APPLICATION NO.	FILING DATE	FIRST NAMED INVENTOR	ATTORNEY DOCKET NO.	CONFIRMATION NO.
10/022,013	12/13/2001	John P. Hansen	SC11218TH	2814

Office Action Summary

DETAILED ACTION

FIG. 1

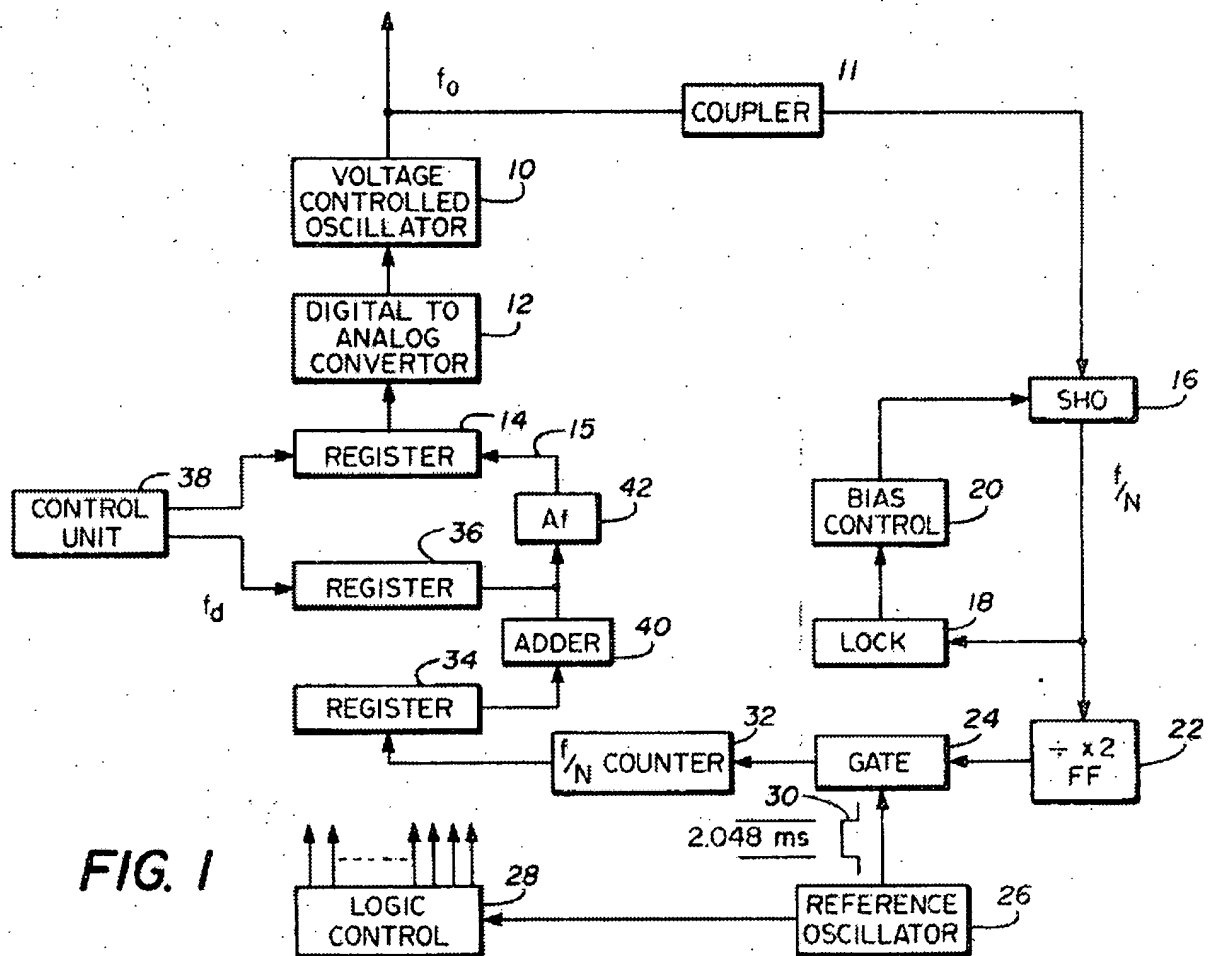
a register coupled to the output (See registers in Fig. 1 below), the register to hold the second signal as a plurality of bits, the plurality of bits comprising at least one most significant bit and at least one least significant bit (Col. 8, lines 6-65); and

adder logic coupled to the input and the register (See adder in Fig. 1, below), the adder logic, responsive to the first signal, to adjust a magnitude of the second signal by the at least one most significant bit (Col. 8, lines 41-51).

Fig. 1

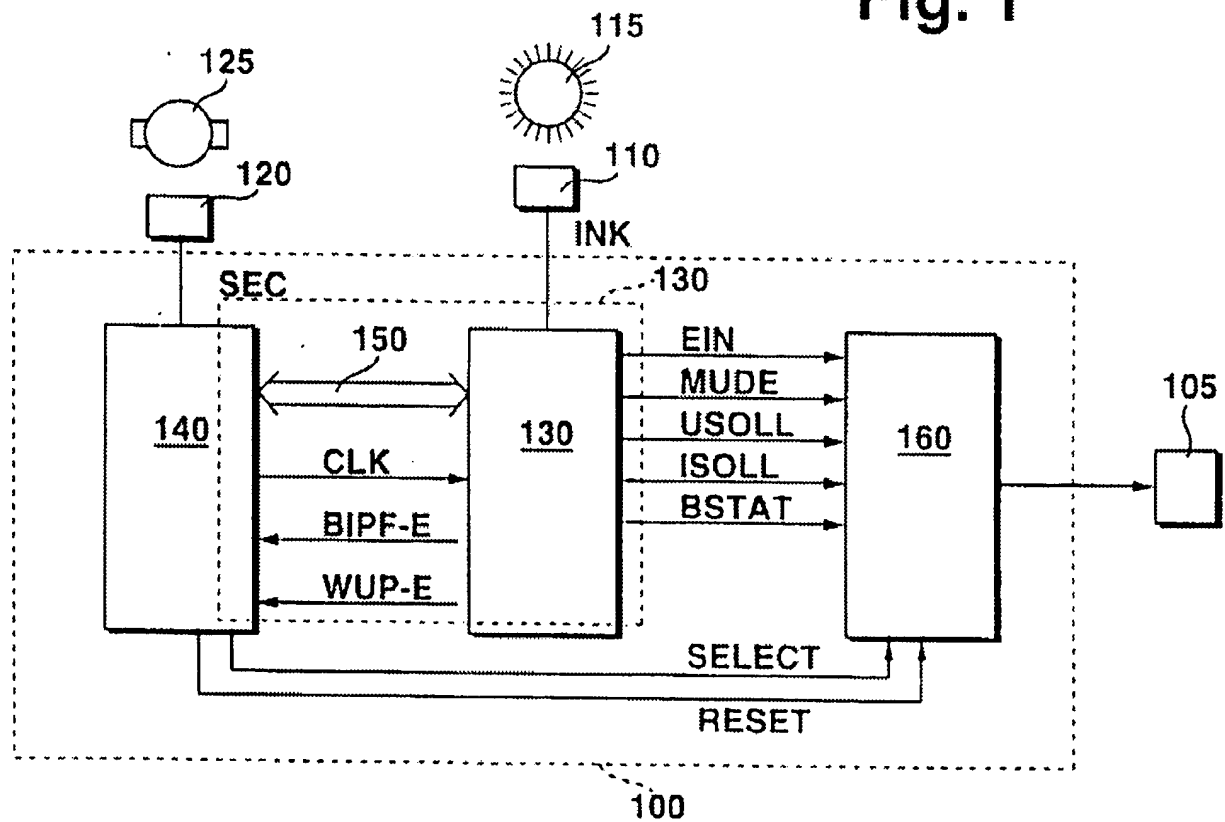
Referring to claim 1, Klatt teaches a domain control system (Col. 2, lines 48-51)

a first manager comprising first logic, the first logic responsive to a first signal (Col. 1, lines 55-64), to provide a second signal representative of a first domain and a third signal representative of a second domain (Col. 2, line 66 – Col. 3, line 25); and

a second manager comprising second logic coupled (Col. 2, lines 18-29) to the first logic (Fig. 1, element 130; Col. 2, lines 52-57), the second logic responsive to the second and third signals to operate on a first value representative of the first domain (Col. 3, lines 7-25) and on a second value representative of the second domain (Col. 8, lines 38-63), and to provide a fourth signal to control an event defined by the first and second values (Col. 1, lines 53-54; Col. 2, lines 25-29).

*Fig. 3*

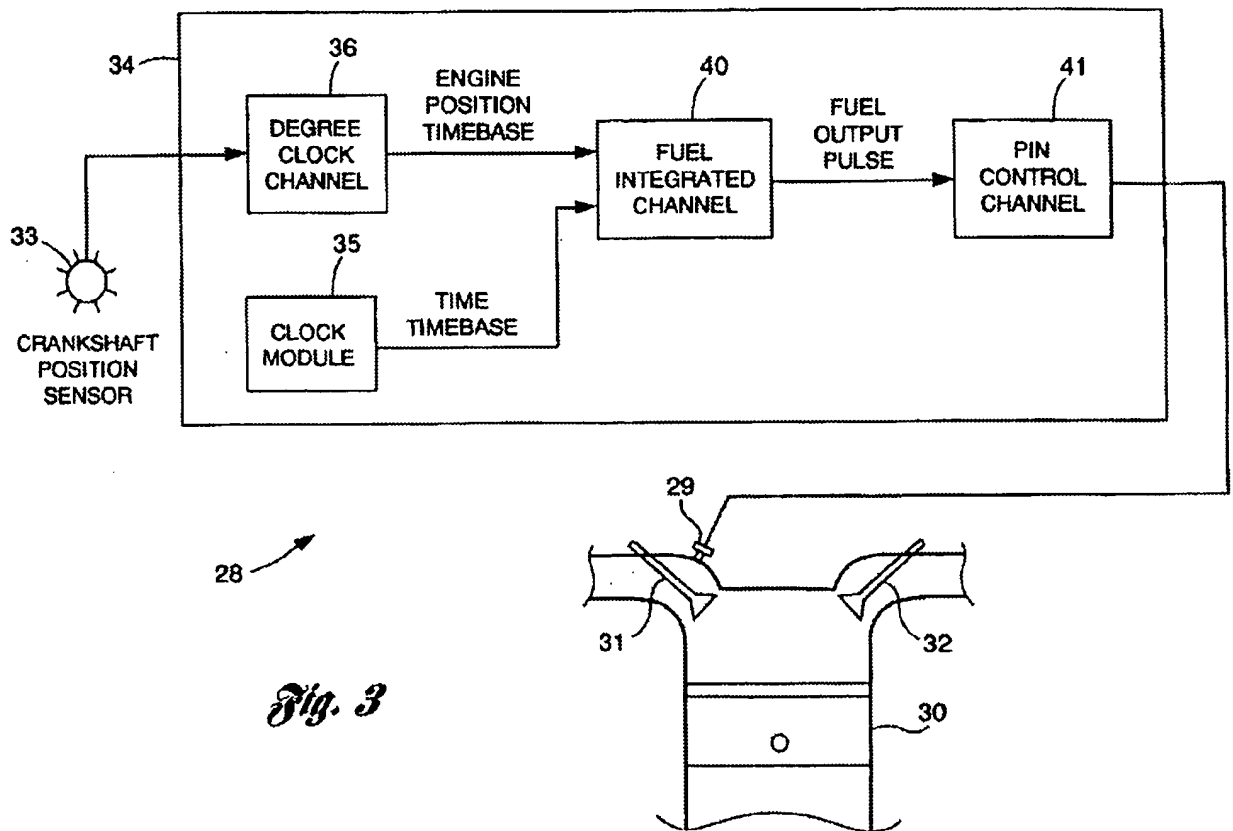
Referring to claim 1, Guido teaches a domain control system (Col. 1, lines 14-18) comprising:

a first manager comprising first logic, the first logic, responsive to a first signal, to provide a second signal representative of a first domain (Fig. 3, element 36);

a third signal (i.e., clock module) representative of a second domain (Fig. 3, element 35);
and

a second manager comprising second logic coupled to the first logic, the second logic, responsive to the second and third signals (Fig. 3, element 40), to operate on a first value representative of the first domain and on a second value representative of the second domain, and to provide a fourth signal to control an event defined by the first and second values (Fig. 3, element 41; Col. 3, line 6 – Col. 4, line 61).
